6 March 2024

## **SUBMISSION OF COMMENTS BY THE ORGANISATION UNDOING TAX ABUSE (OUTA) TO THE DRAFT INTEGRATED RESOURCE PLAN FOR ELECTRICITY IRP 2023**

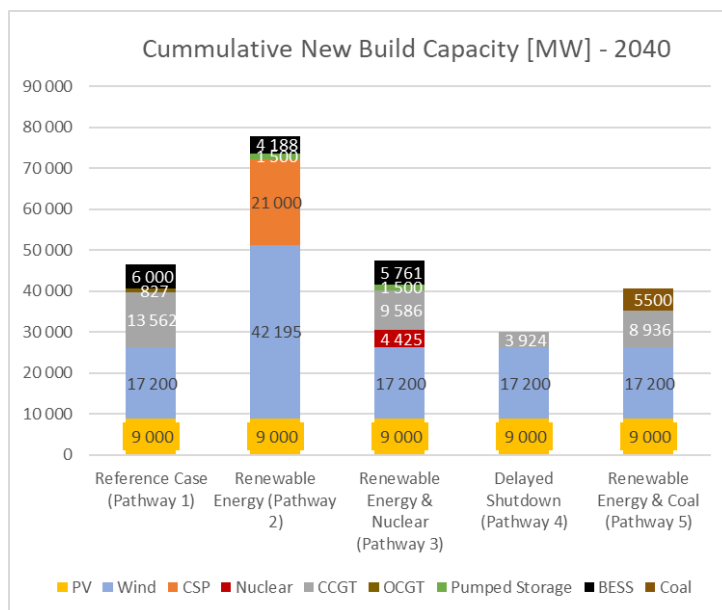
- It appears from the above figure, and Figures 13, 14, 15, 17 and 18 in the Draft IRP 2023, that new-build constraints were applied, because the outcomes across all Horizon 2 pathways show clearly that solar PV was constant in all pathways and could not exceed 9000 MW cumulative per decade (900 MW per annum).

Figure 21: Carbon Emissions Analysis for both Horizons

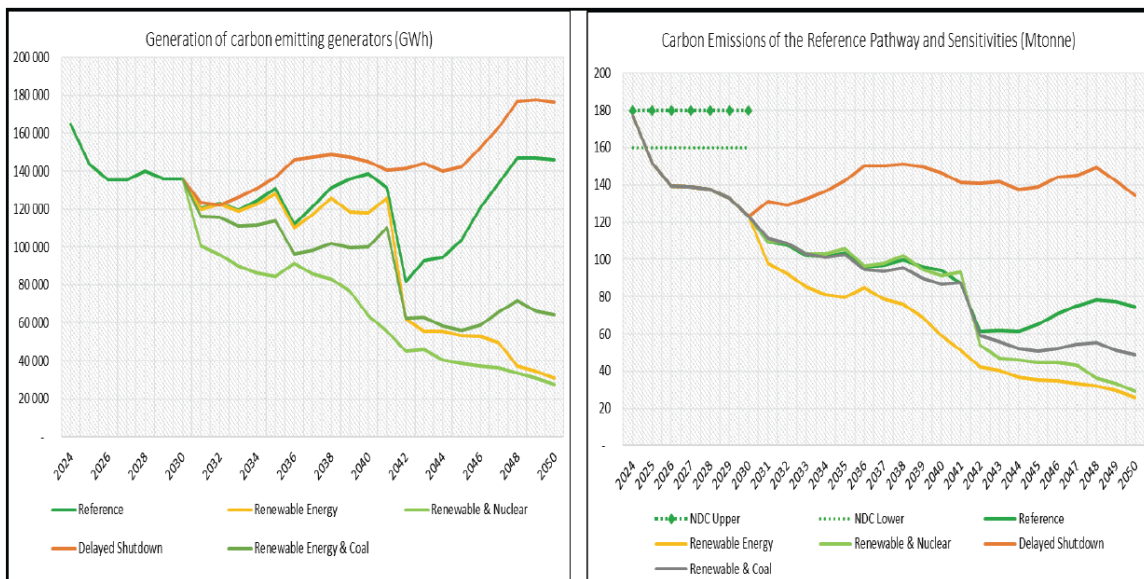
- The emissions starting point at the end of 2023 is 180 MtonneCO<sub>2</sub>e, which is significantly below the emissions of 200 MtonneCO<sub>2</sub>e reported for the end of 2022 by Eskom in their annual reports. It is possible that this discrepancy is due to extreme levels of loadshedding in 2023, but the DMRE needs to provide its emissions reduction calculations in this regard..

- The reduction in CO<sub>2</sub>e emissions from 2024 to 2030 is disproportionate to the reduction in energy output. Figure 21 shows a reduction in roughly 23 000 GWh with corresponding reduction of 40 000 MtonneCO<sub>2</sub>e. This does not align with emissions factor of 1.013 tonneCO<sub>2</sub>e/MWh published by the DFFE, and requires further explanation by the DMRE.

- The range of CO<sub>2</sub>e emissions limits for the Horizon 1 period from 2024 to 2030 is indicated in Figure 21 as 160 to 180 MtonneCO<sub>2</sub>e. This is different to that calculated by OUTA of 140 to 190 MtonneCO<sub>2</sub>e (based on an 80% share of reductions). It is important to align on the contribution by the power sector towards meeting the NDC (Nationally Determined Contribution) targets for reduction of CO<sub>2</sub>e, and OUTA and the DMRE need to resolve this issue.
